Access Compliance Report

Public Rights-of-Way

(Curb Ramps)

Intersection ID: 6481	Main Street: LOTHAR RIDGE LN	Cross Street: SLATER SPRINGS DR	Location: NE
ADA ID: EDCECECA34F1	Ramp Type: BlendTrans1	Initial Pass/Fail: Fail	Overall Compliance: No
Severity Score: 21.25			
Codes/Mitigation Info/Possible Solution		Field Measurements/Component Compliance

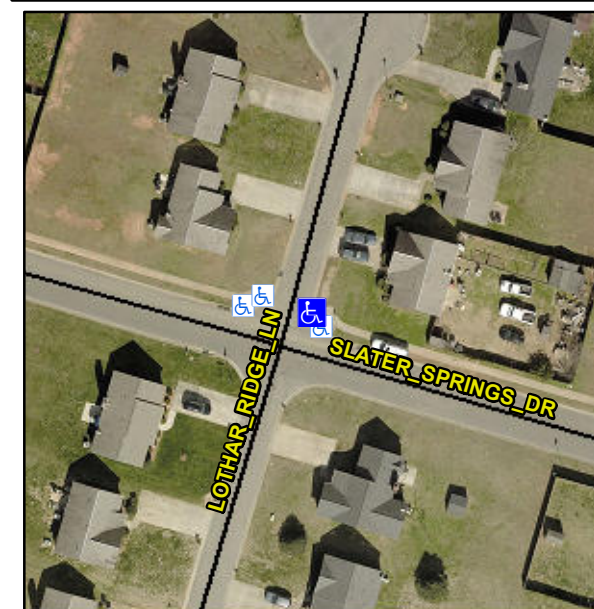
NO LT SW

Not Found, R304.5.1, R304.5.3

Compliance	Description	Data	Compliance	Description	Data
N/A	Ramp Length (in)	56.0	Yes	BlendTrans Slope (%)	2.9
No	Ramp Width (in)	38.0	No	BlendTrans XSlope (%)	5.1
N/A	Flare Type LT	N/A	N/A	Flare Type RT	N/A
N/A	Flare Slope LT (%)	N/A	N/A	Flare Slope RT (%)	N/A
N/A	Flare Traversable LT?	N/A	N/A	Flare Traversable RT?	N/A
N/A	Landing Length (in)	N/A	N/A	DWS Provided?	N/A
N/A	Landing Width (in)	N/A	N/A	DWS Contrast?	N/A
N/A	Landing Slope (%)	N/A	N/A	DWS Length (in)	N/A
N/A	Landing X Slope (%)	N/A	N/A	DWS Full Width?	N/A
N/A	Landing Curb? (Y/N)	N/A	N/A	DWS Offset (in)	N/A
N/A	Shared Landing?	N/A			
N/A	Gutter Ponding?	N/A	N/A	Gutter Slope (%)	N/A
N/A	Gutter Lip Ht (in)	N/A	N/A	Gutter X Slope (%)	N/A
N/A	Painted X Walk1?	No	N/A	Painted X Walk2?	N/A
	X Walk 1 Direction	To NW		X Walk 2 Direction	N/A
	X Walk 1 Width (in)	N/A		X Walk 2 Width (in)	N/A
	X Walk 1 Slope (%)	2.2		X Walk 2 Slope (%)	N/A
	X Walk 1 X Slope (%)	0.5		X Walk 2 X Slope (%)	N/A

N/A	Ramp inside XWalk1?	N/A	N/A	Ramp inside XWalk2?	N/A
	Road Slope (%)	0.5		Clear Space?	N/A
	Road X Slope (%)	2.2	N/A	Clear Space to XWalk (in)	N/A
N/A	Any Obstructions?	N/A	N/A	Storm Grate/Utility Hazard?	N/A
	Obstruction Type			Storm Grate/Utility Type	
		N/A			N/A
			Yes	Surface Condition? (G/P)	Good
			No	Curb Slope (%)	20.9

Remove & Replace Curb Ramp With Two New Directional Ramps or Equivalent.
